Re: Response to MassDEP Comments
444 East Central Street, Franklin MA (DEP File #159-1306)

1.0 MASSDEP COMMENTS AND RESPONSES

DRAWING TITLE: **IWW EXHIBIT** SHEET No. **EX-1**

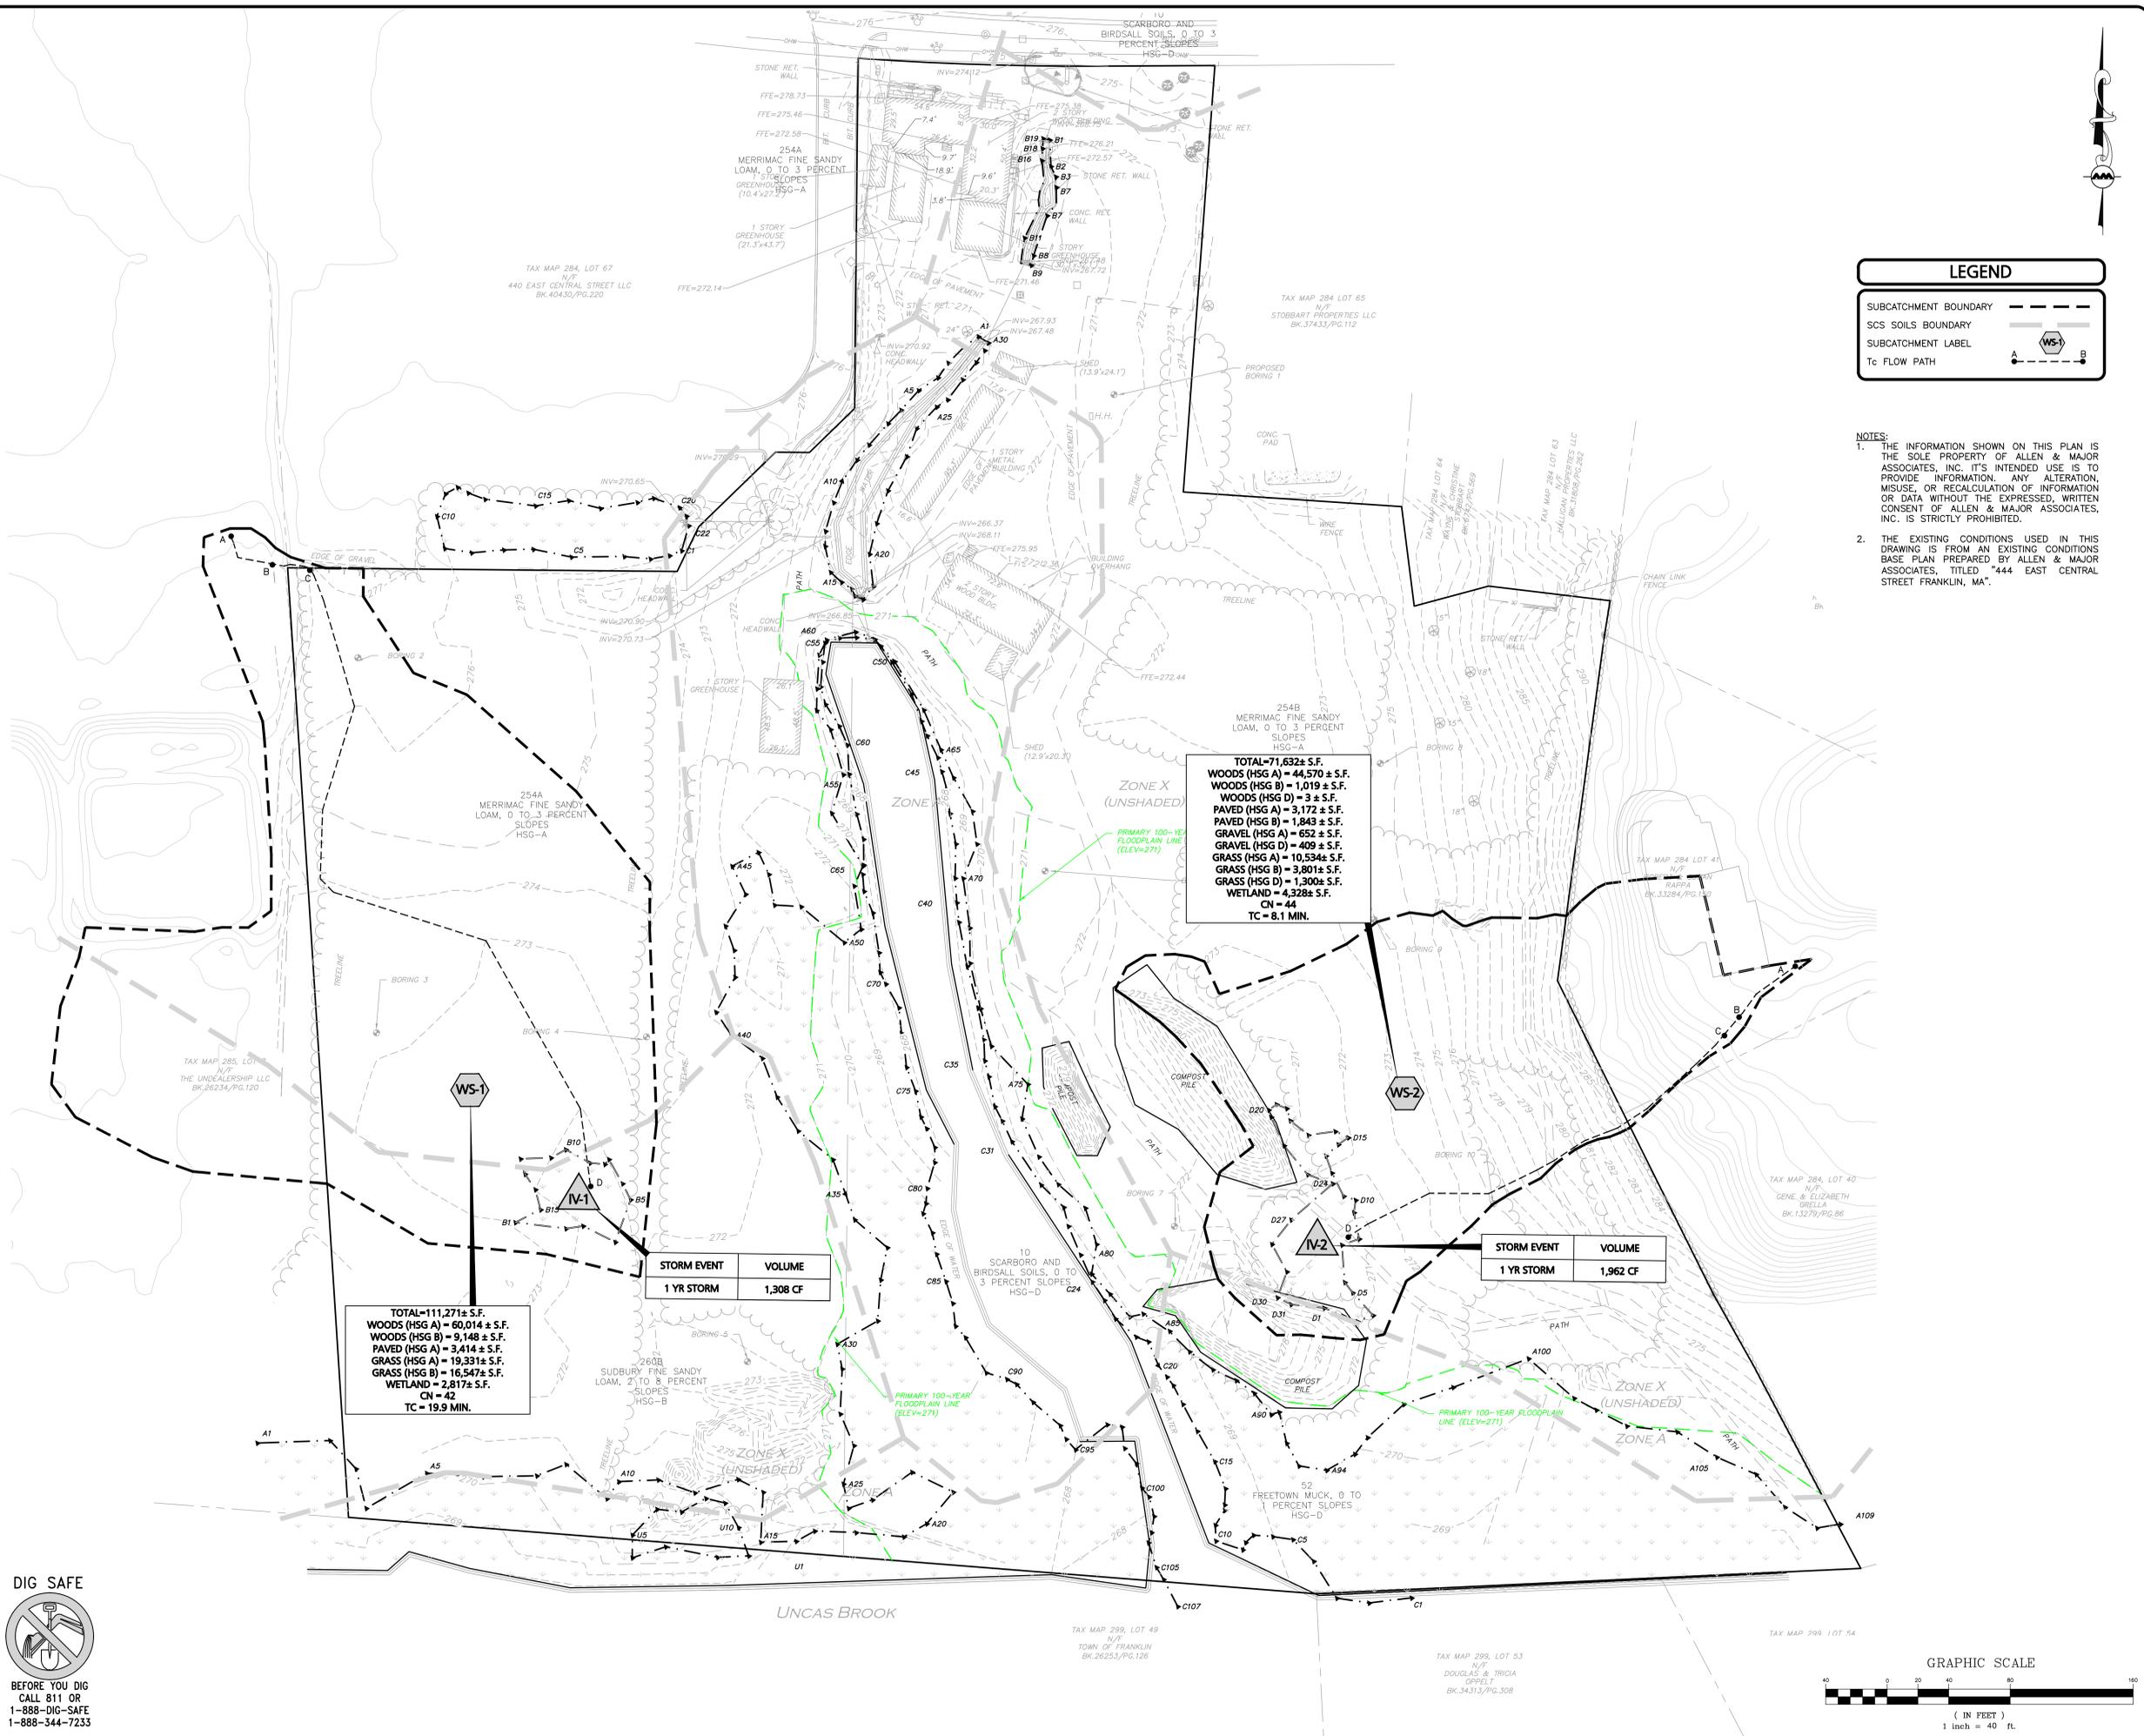
#2	<p>The Applicant should provide additional information in accordance with 310 CMR 10.57(2)(b)3. to verify whether the isolated vegetated wetlands meet parameters to be considered isolated land subject to flooding and jurisdictional under the WPA.</p> <p>Additionally, if the Applicant suspects that the isolated wetlands were once stormwater management features, additional information in accordance with 310 CMR 10.02(2)(c) should be provided to MassDEP and the Commission demonstrating when the basin was installed and that the stormwater basin has been maintained as such. The Commission may request that the Applicant submit maintenance logs. MassDEP recommends the Commission should verify that the GCC series does not connect to the wetland system. If a connection does exist, based on the information provided the GCC series may be considered jurisdictional even if it was a stormwater basin previously. Please provide additional information accordingly.</p>	<p>A&M has prepared engineering calculations to confirm that the isolated vegetated wetlands are not capable of containing ¼-acre foot of water and therefore cannot qualify as Isolated Land Subject to Flooding (see attached IVW Exhibit and HydroCAD calculations).</p> <p>It does not appear that either of the on-site IVWs (GCB- or GCD-series) were constructed as stormwater basins.</p> <p>Goddard and A&M do believe that the GCC-series wetland was constructed as a stormwater basin, but it does not appear to have been maintained due to the presence of large woody vegetation. As such, it has been identified as a vegetated wetland to accurately display the 100-foot buffer zone that casts onto the locus site. Goddard and the Applicant are investigating any potential connection and will provide revised plans to the Commission and MassDEP as appropriate.</p>
